**MAP ACCURACY REPORT**  
**Countywide Imagery & DEM**  
**Crow Wing County**

<b>Data Contact Person:</b>	Don Sigety, LS	<b>Department:</b>	County Surveyor
<b>Type of Mapping:</b>	DEM (LiDAR) & Ortho	<b>Contractor:</b>	Merrick & Company
<b>Independent Testing:</b>	Mn/DOT Photo Unit	<b>Contract Delivery date:</b>	2 April 2008

**Project Identification:** Crow Wing County Digital Elevation Model and Orthophoto

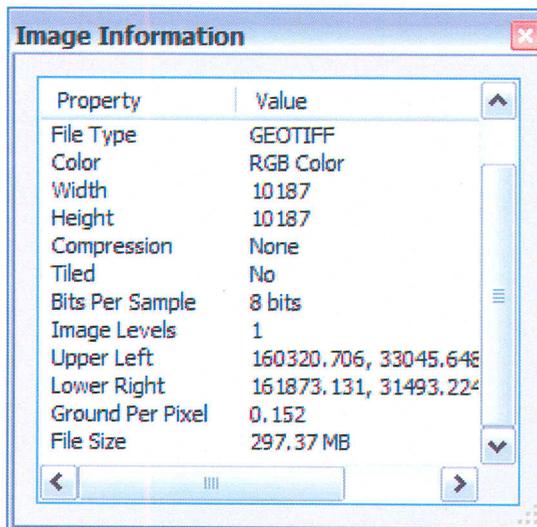
I have looked over Area's 2 & 3 and have discovered something interesting. I don't see this as an error but more as requiring an explanation. If you look at the attached document you will notice the first properties picture (ESRI) shows the proper coordinates and datum. I believe that this comes from the world file. The second picture (non-ESRI) shows the properties where the coordinates and datum are not specified. The interesting thing is that the coordinates and resolution are in meters. If you multiply the coordinates by (3937/1200) you do get the proper Crow Wing County Coordinates. Same is true with the resolution. This is also the same for Area 1.

However if you use the TIFF's in something like a MicroStation's Raster Manager you don't get the images to come into the correct place. MicroStation does not read the World file automatically, you have to let it know what to do. I don't know if this is true with AutoCAD because I don't have a copy of AutoCAD. Don Sigety might have to look at this. Anyway you look at this, it requires first hand knowledge of this situation in order to perform the switch correctly and maybe this is one of the things you give up when ordering two sets of coordinates systems for a final deliverable.

"After review, it appears the GeoTIFF attributes somehow got corrupted when transformed from the UTM projection. These will be corrected and resubmitted with the Area 3 delivery."

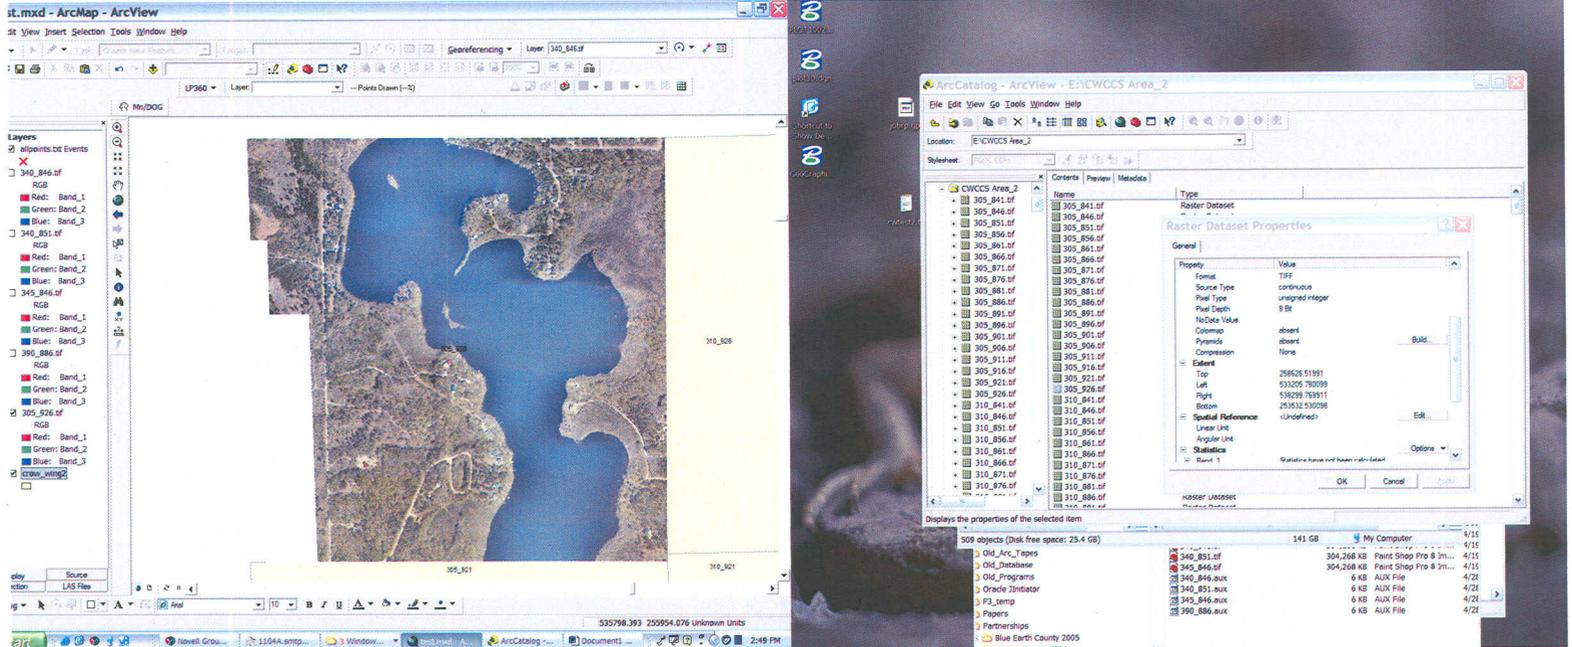
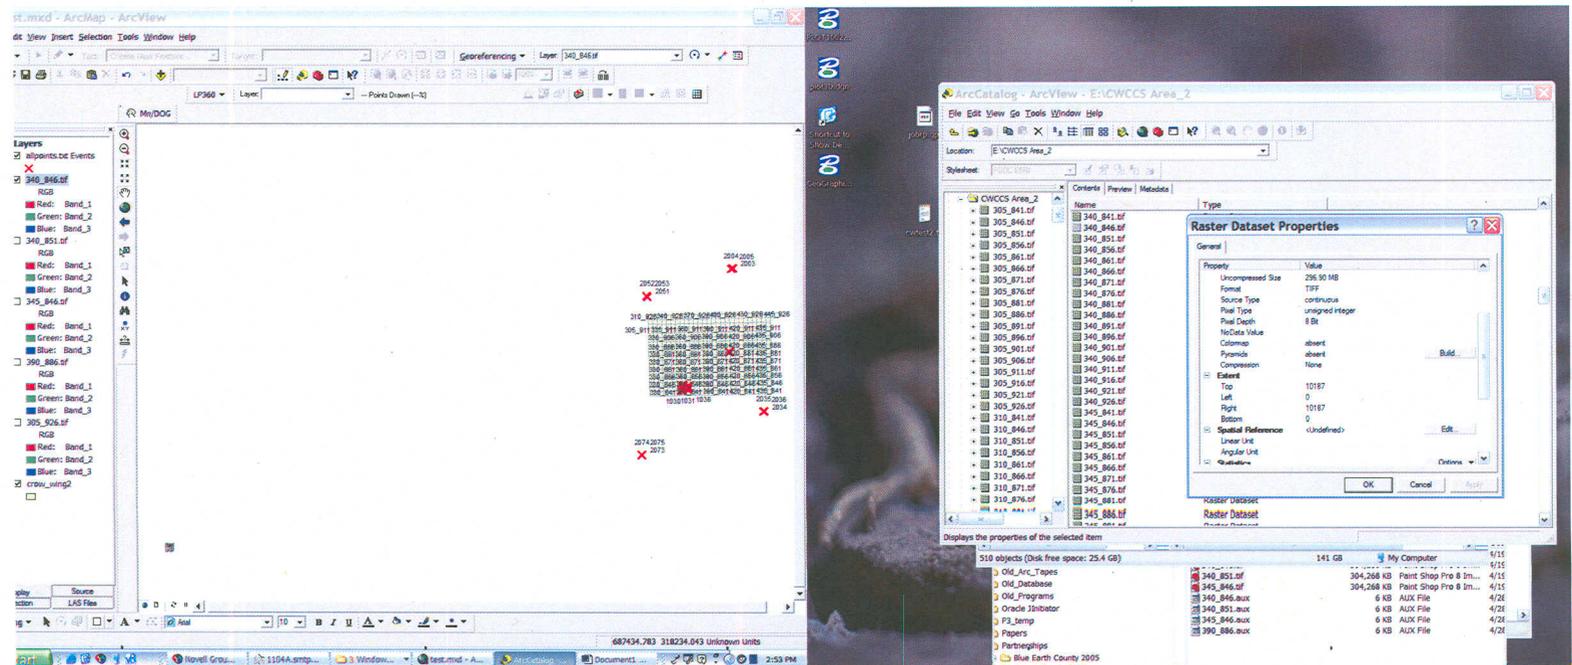
Here are some screen shots showing how the images are coming in. I didn't check all the images, but out of about 20, only one displayed correctly and had a spacial extent listed.

Image has extent listed and comes in correctly

Image has no extent and comes in incorrectly.
